3.0 COMMENTS AND RESPONSES

3.1 Geology, Soils and Topography Comments and Responses

Figure 3.1-1: Soils Map
Buena Vista Teutonia PUR
 City of Yonkers, Westchester County, NY
 Source: Westchester County GIS, 2006 Soil Survey (SSURGO)
 Scale: As shown

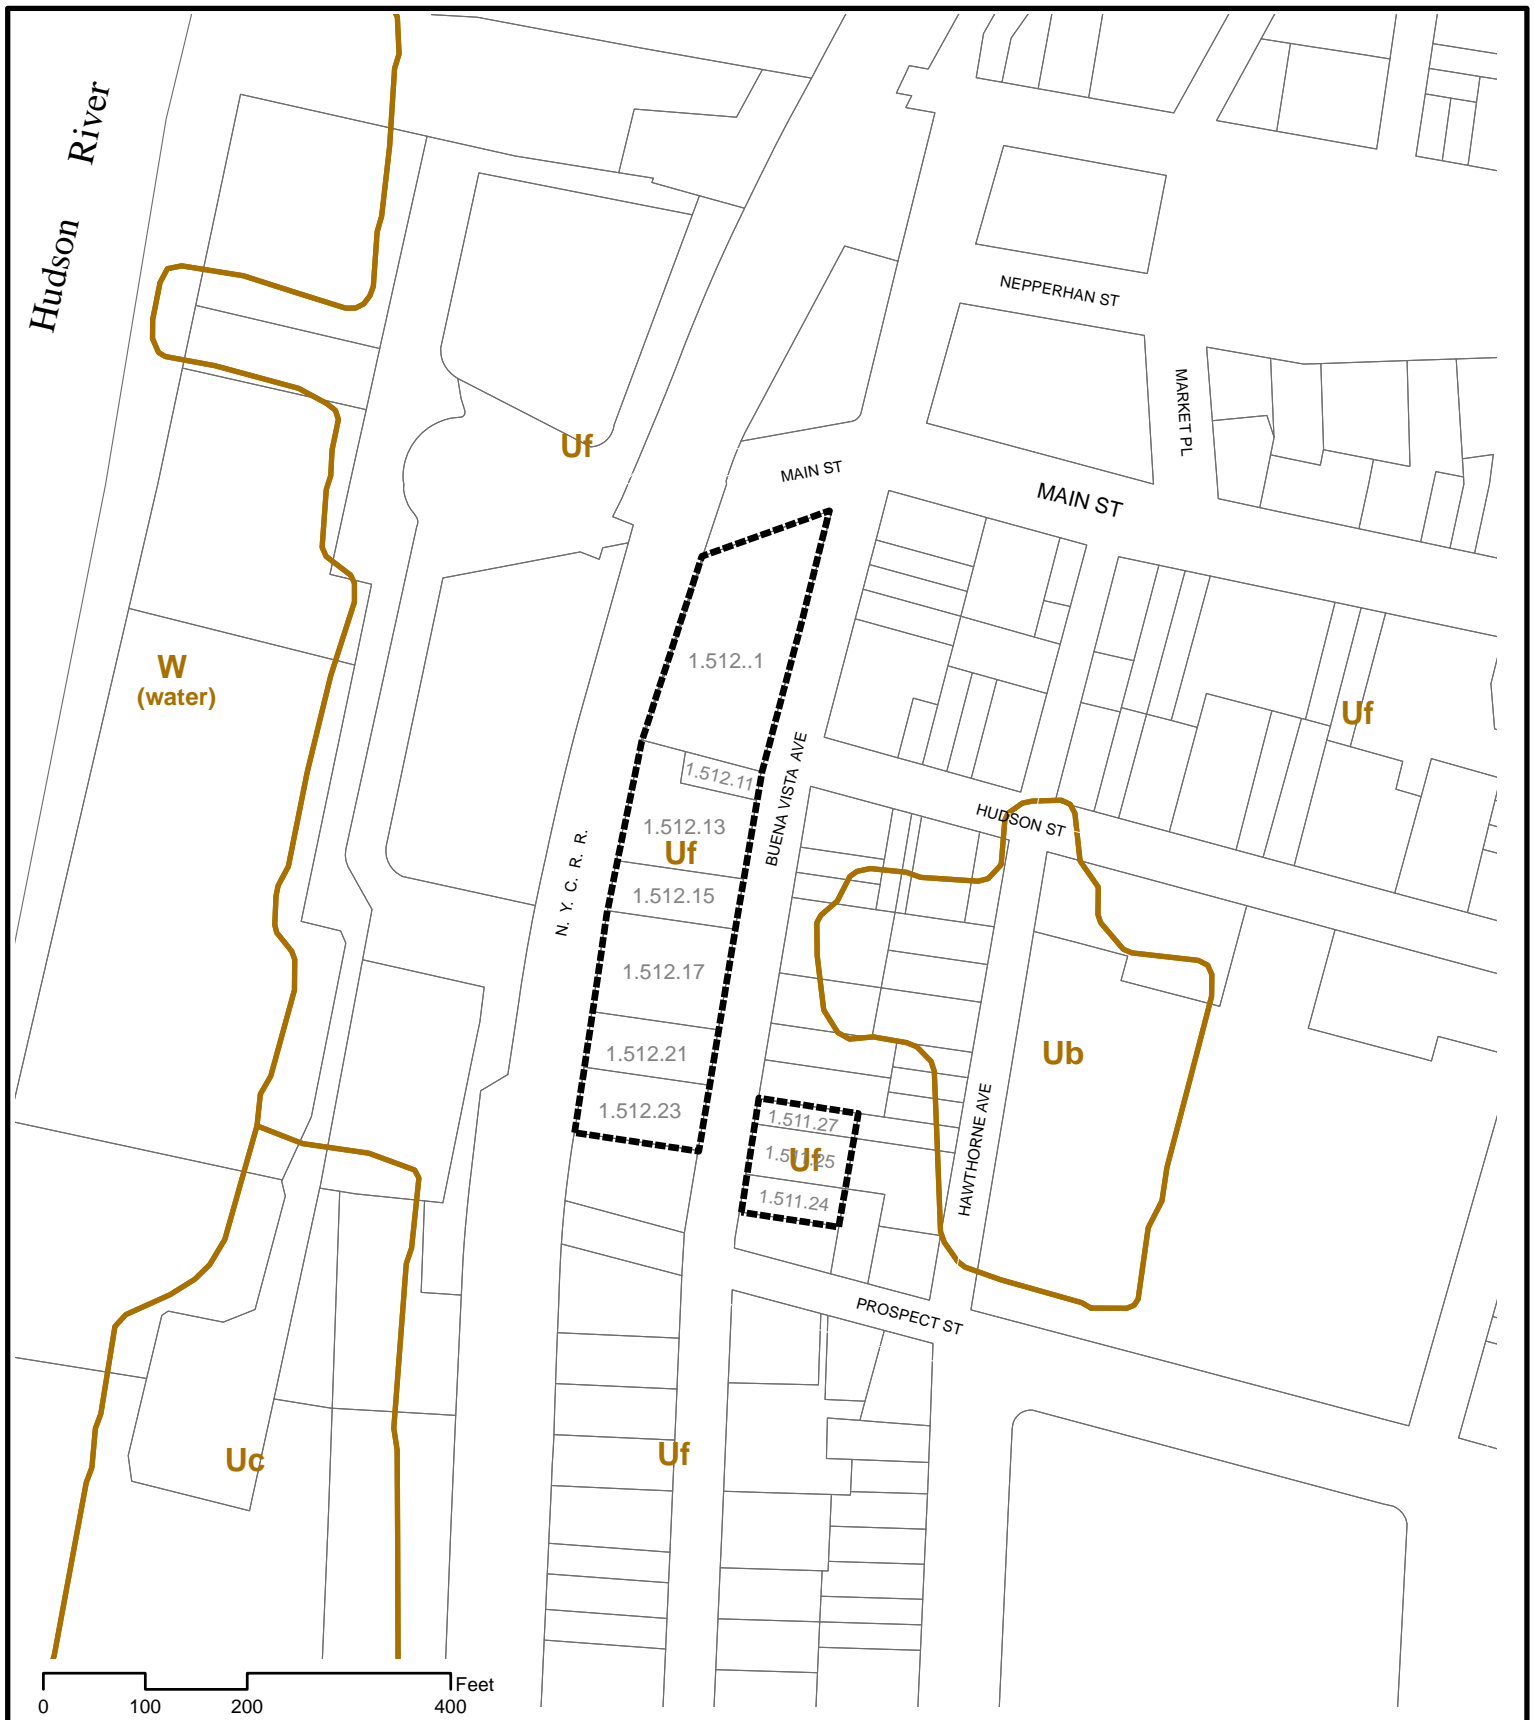
Comment 3.1-22 (Letter 18, April 22, 2011, Yonkers Dept. of Planning & Development):
Figure 3.1-1 Soil Map Key needed for the soil types.

Response 3.1-22: *A key is now provided in the revised Figure 3.1-1 Soils Map.*
